APPEAL SUMMARY

Appeal ID: 24867	Project Address: 7000 NE Airport Way
Hearing Date: 5/12/21	Appellant Name: Tara Lund
Case No.: B-007	Appellant Phone: 5032261285
Appeal Type: Building	Plans Examiner/Inspector: David Bartley
Project Type: commercial	Stories: 3 Occupancy: A-3, B, S-1 Construction Type: Type IA
Building/Business Name: Port of Portland - PDX	Fire Sprinklers: Yes - Throughout
Appeal Involves: Alteration of an existing structure	LUR or Permit Application No.: 20-124057-STR-01-MG
Plan Submitted Option: pdf [File 1]	Proposed use: Airport

Appeal item 1

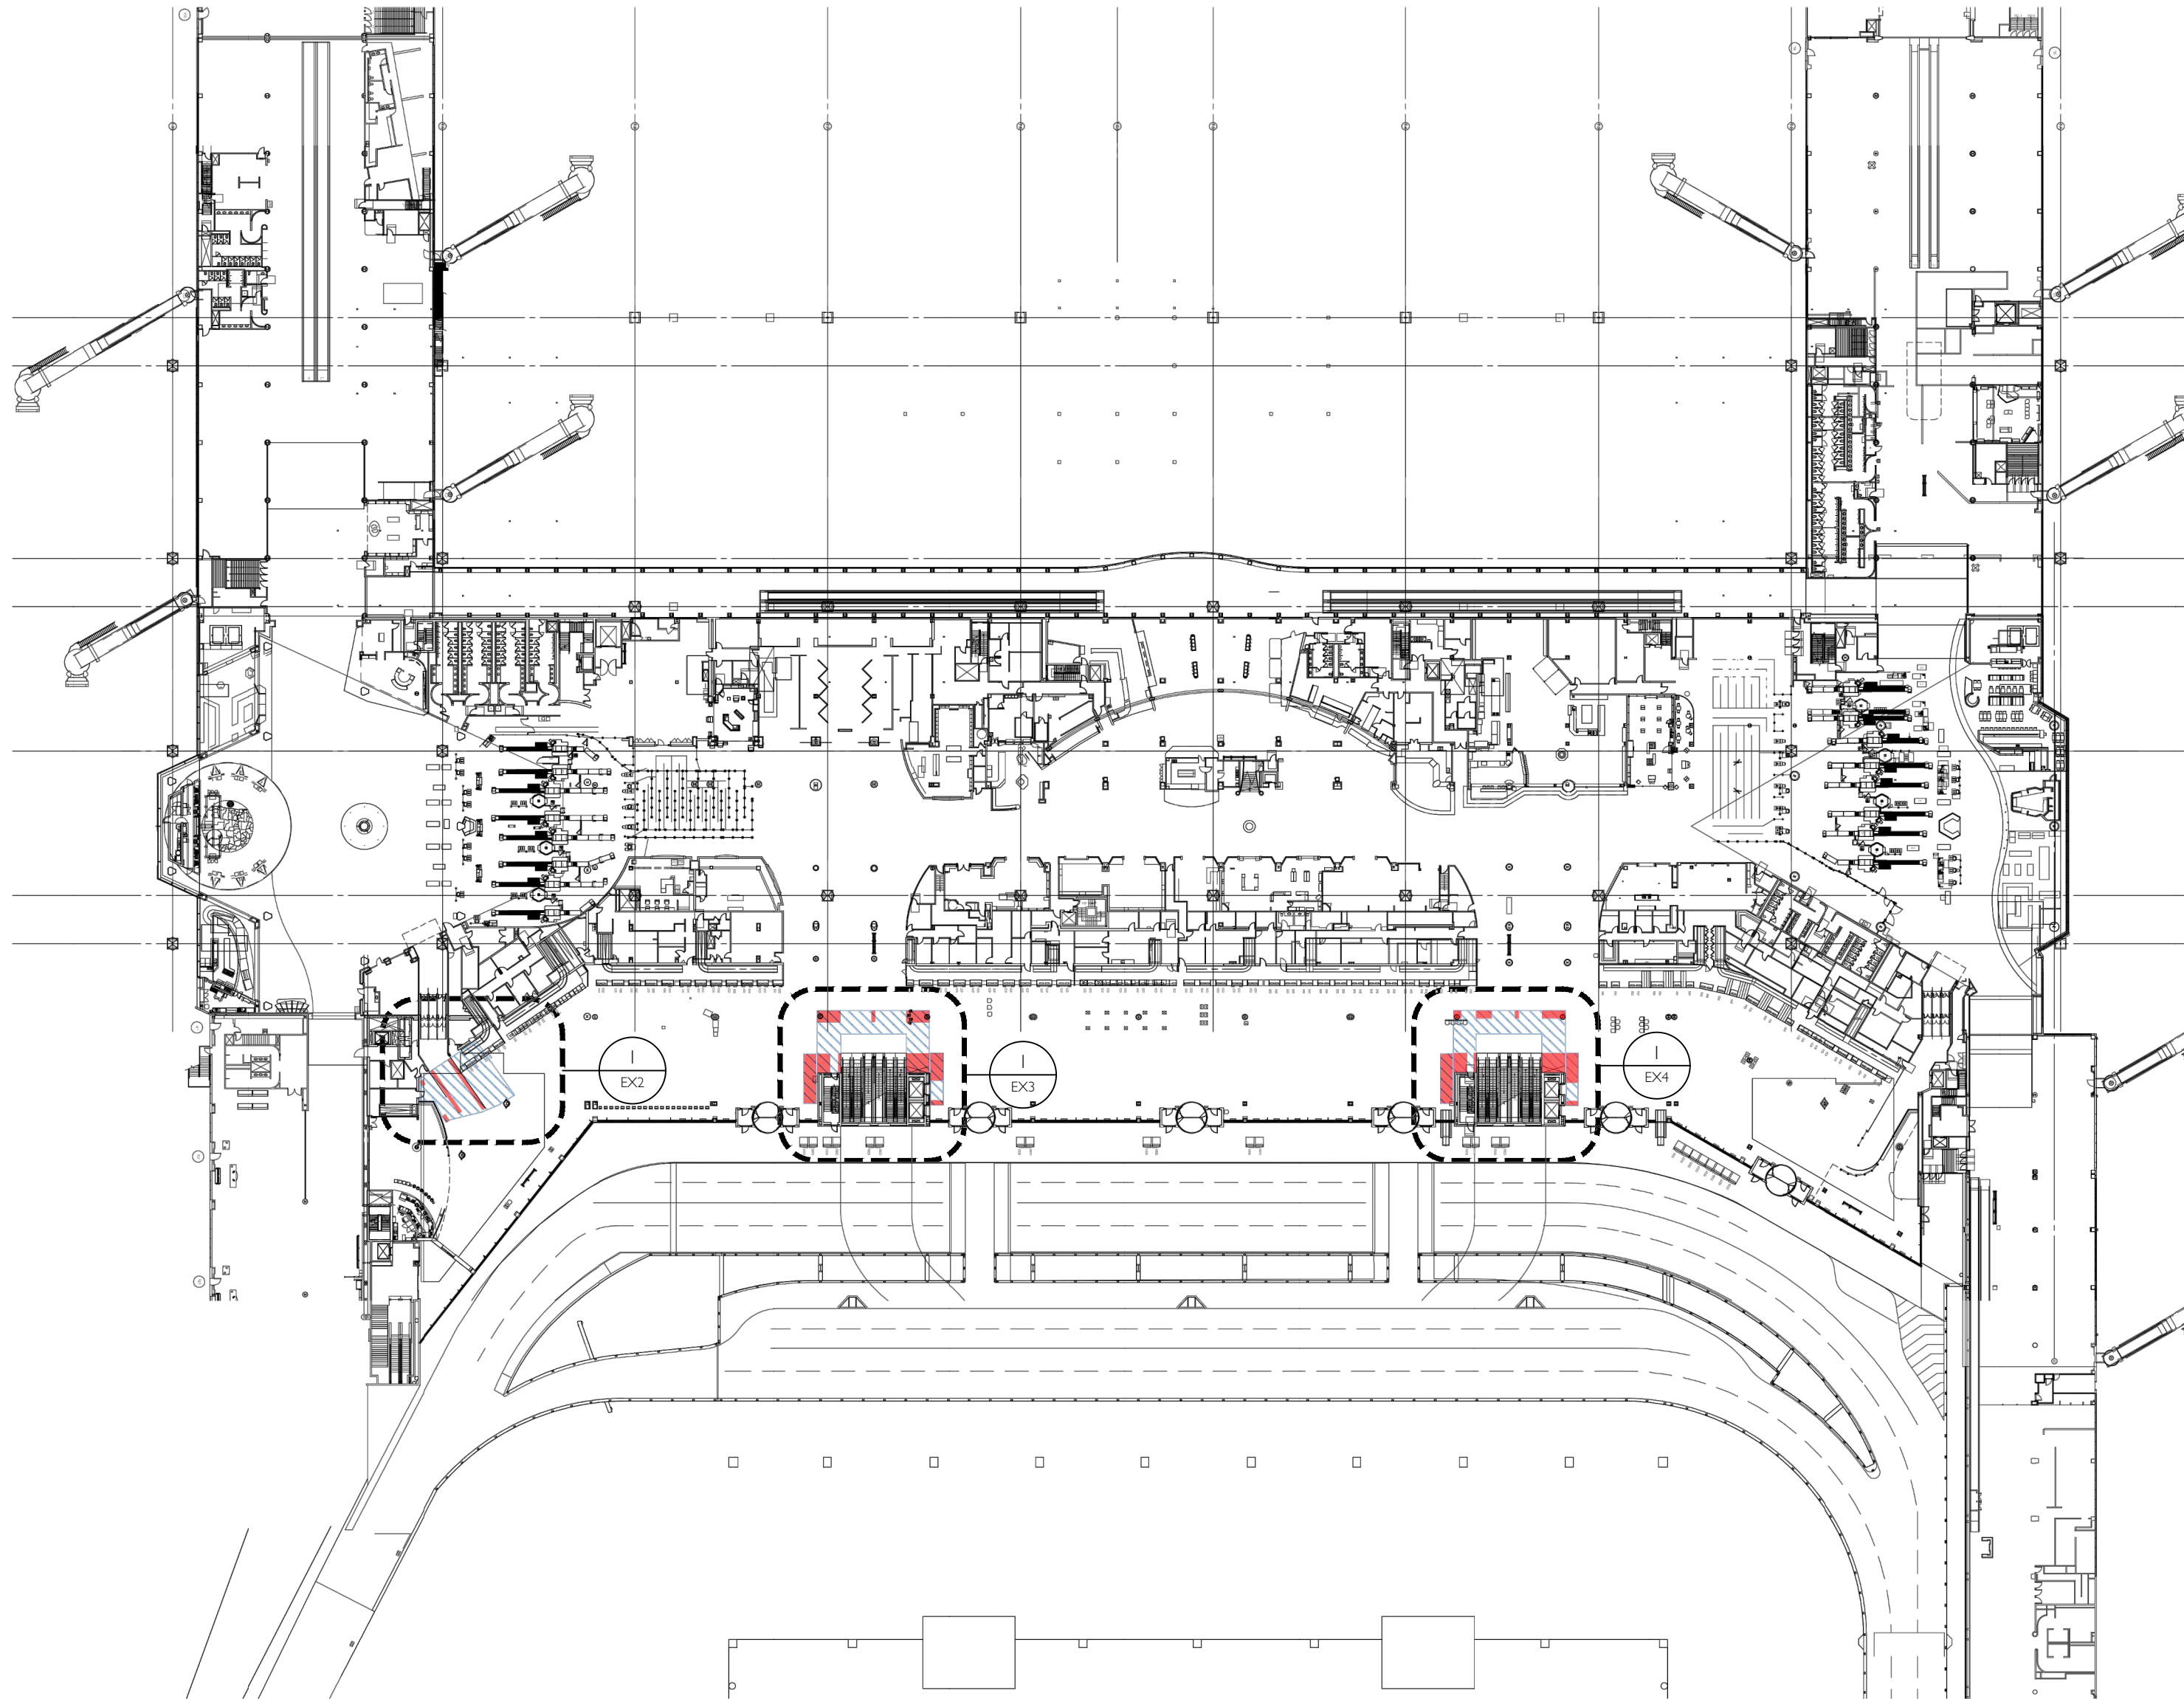
The scaffolding work platform will be roughly 19' above enplaning floor and the area of work will range 10'-0" to 15'-0" above the work platform. The platform will have netting, guardrails and toe boards as required to meet OSHA standards. Any work that involves heavier construction elements, including movement of rain drains, will take place during the night shift with the area below vacated of all non-construction personnel.

Reason for alternative The load capacity of the scaffolding is limited by the point load capacity of the existing terminal roof and enplaning floor structure in this area. The proposed scaffolding is meant to operate as a working platform for work with limited risk of falling debris and therefore, the platform will not be subject to loads that would require overhead fall protection in the magnitude of the 150 psf live loading across large areas of the scaffold platform.

Please see: EX1, EX2, EX3 & EX4

Modification to the minimum scaffold live load requirement: Granted as proposed.
